Peat Depth

Mossy Hill Wind Farm

Non-Material Variation to 2023/084/VCON (2018/186/PPF)

Figure 2e
Peat Depth
Mossy Hill Wind Farm
Non-Material Variation to 2023/084/VCON
(2018/186/PPF)

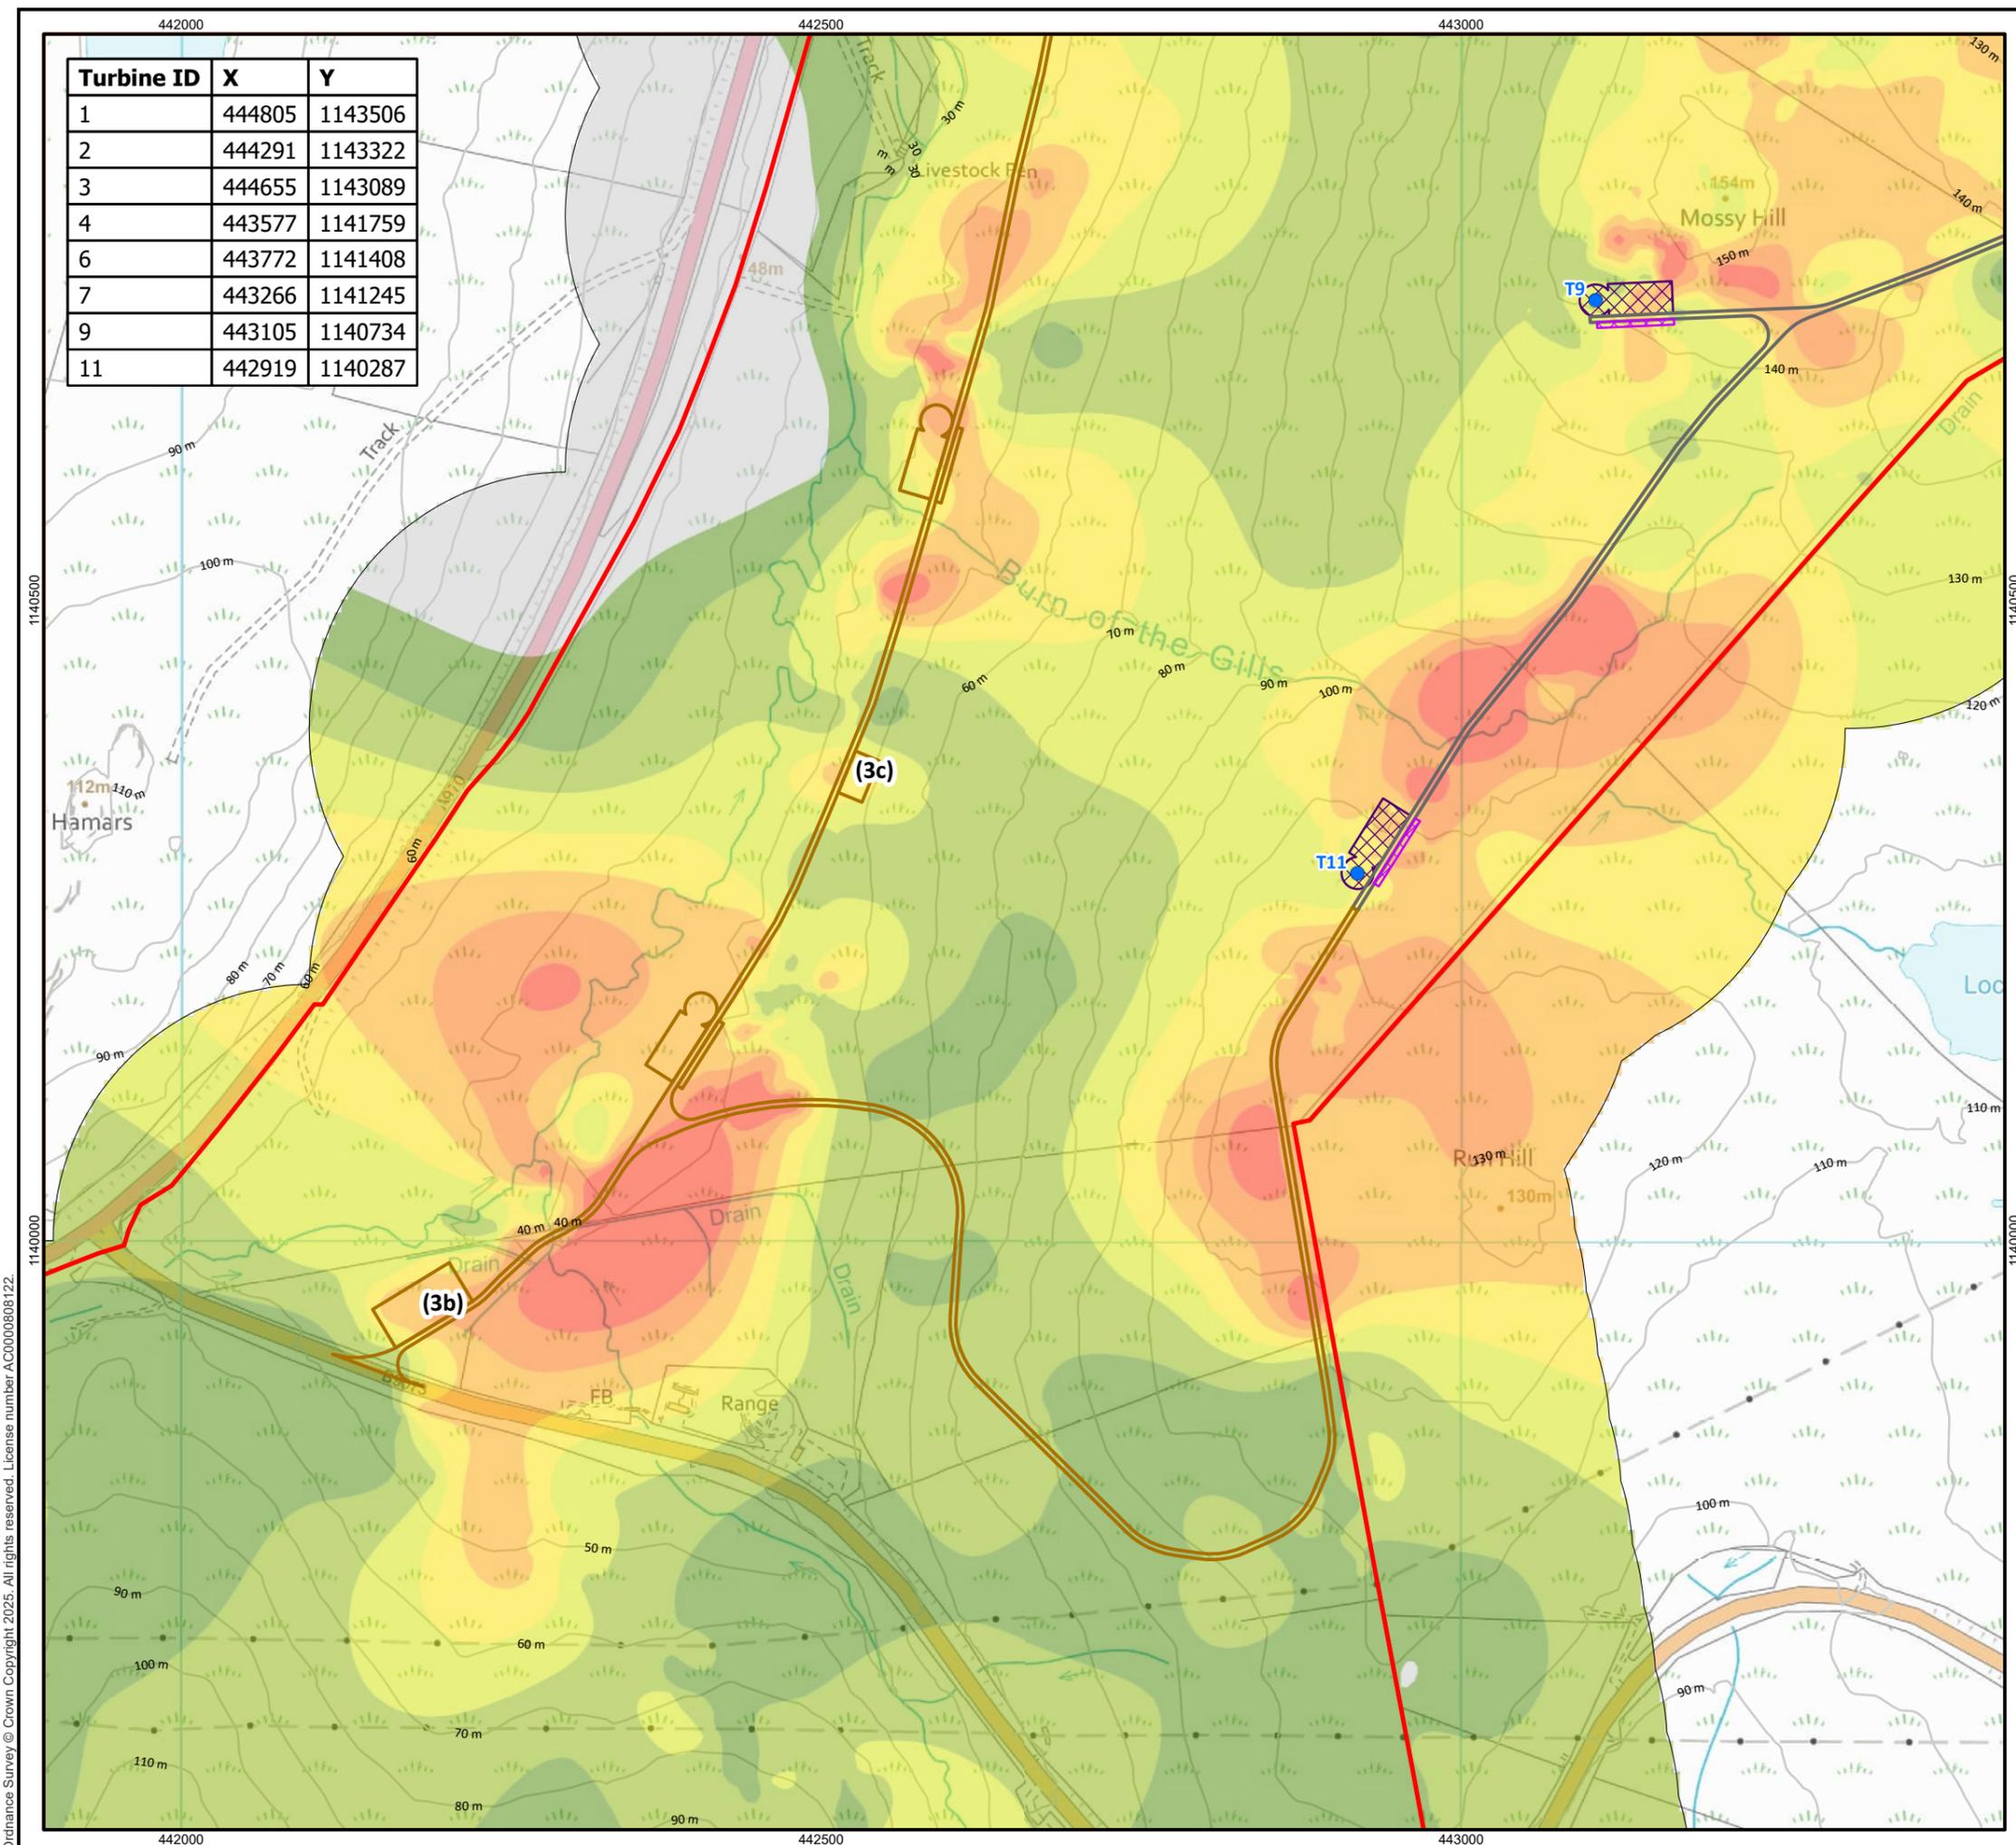
(1) Removal of Turbines T5, T8, T10, T12, associated infrastructure, tracks and the B9073 access junction

(2) Amendment to the track linking the consented substation to wind farm track, removing loop and shortening length. Addition of link tracks to construction compounds

(3a) Relocation of northern wind farm temporary construction compound

(3b) Removal of southern temporary construction compound

(3c) Removal of southern substation

(3d) Revised substation design and layout as approved via planning permission Ref: 2024/303/PPF granted on 12th June 2025
